### Review of Adequacy of ESIA Environmental Mitigation for the CNOOC Kingfisher Oil Development Project

#### May 12, 2019

#### Bill Powers, P.E., E-Tech International

## Figures 3a and 3b. Alternative well pad location (blue dot) above the escarpment relative to proposed wells and proposed Lake Albert shoreline well pads

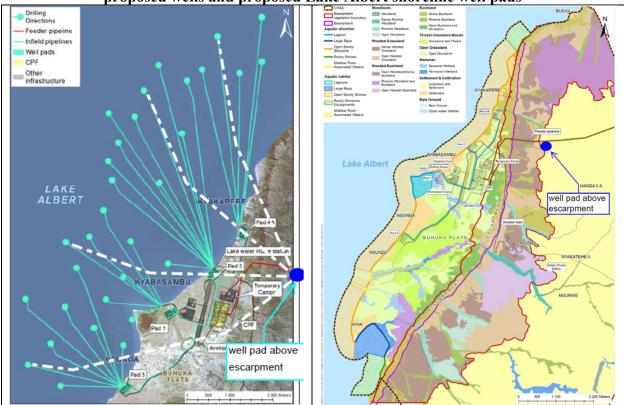
ERD from a single well pad above the escarpment, large enough to concurrently drill two wells, should be utilized to drill the planned Kingfisher oil production wells and produced water wells. Both CNOOC and Total have been drilling ERD wells of 8 km or longer for more than 20 years.<sup>20,21</sup> The maximum ERD well horizontal distance from a well pad above the escarpment would be about 10 km. Only 5 of 31 planned wells would be 8 km or longer.<sup>22</sup> The average horizontal reach would be about 6 km. The average horizontal reach of wells described in the ESIA, drilled from well pads on the Buhuka Flats shoreline, is about 4 km. The approximate location of the alternative well pad location above the escarpment is shown in Figures 3a and 3b.

Note: blue dot added by author represents potential drill pad site above escarpment. Dashed white lines represent potential trajectories of wells drilled from this drill pad site overlaid on the proposed well trajectories in the ESIA.

All of the proposed wells could be drilled from a single drilling pad above the escarpment. Drilling up to 40 wells for a single multi-well pad is a common in North America.<sup>28</sup> Wells are grouped into clusters on the multi-well pad. Two drilling rigs can be operational concurrently on different well clusters on the same multi-well pad. A photograph of a 6-well cluster on a 26-well multi-well pad in Canada is shown in Figure 4.
